Fresno - Bakersfield (2014 June+) - RECORD #398 DETAIL

Response to Submission I001 (Donna Nelson, January 16, 2018)

Figure 4 Project Phase I

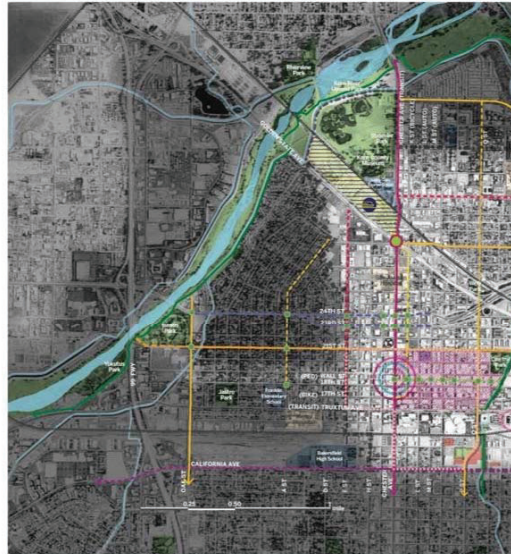
Subject: FW: F St Station
Attachments: Figure 4.jpeg

Refer to Standard Response FB-LGA-Response-GENERAL-02: Public Outreach, FB-LGA-Response-GENERAL-10: Comments with Opinion Only.
